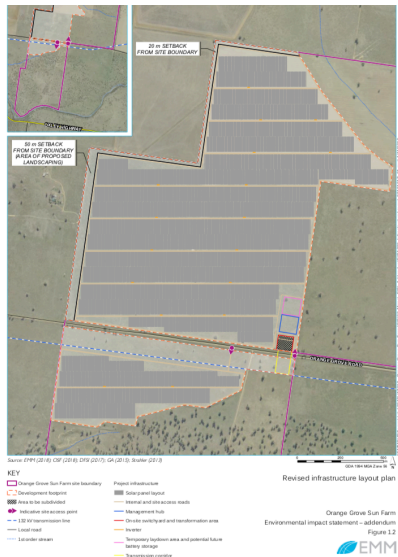
- one example from Tamworth to OG Road of screening

-Setback no 6. – (setbacks considered in layout are subject to change during detailed design phase.)

-detail – internal/external roads query

-Example if setback is left to original design from business entrance.

Figure 4 1984 Flood (near flood peak)

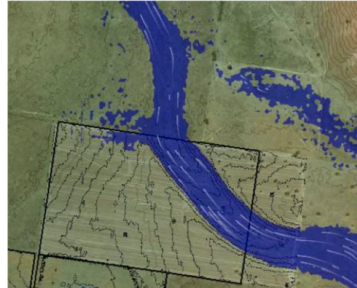
- The results of the 1984 model simulations, identified under the DRAFT Floodplain Management Plan 2016 as the "Large Design Flood", showed that the mapped 1st order watercourse would likely be a breakout channel for the Namoi River (Figure 4). It is expected that this channel would have conveyed flood flows in the 1984 flood.

Top right – 1984 break flow

Figure 2 Upper Namoi Valley Floodplain Management Zones

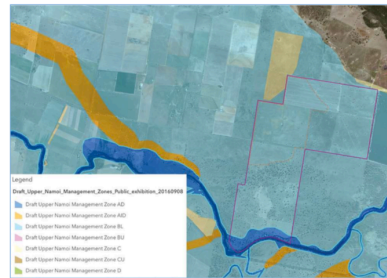
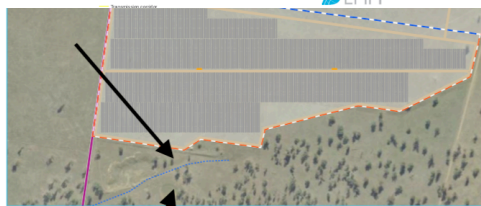
Top left-new design considering northern first order water path

Left-southern first order water path not addressed

Right-Figure 2 – from report 1984 flood flood prone based
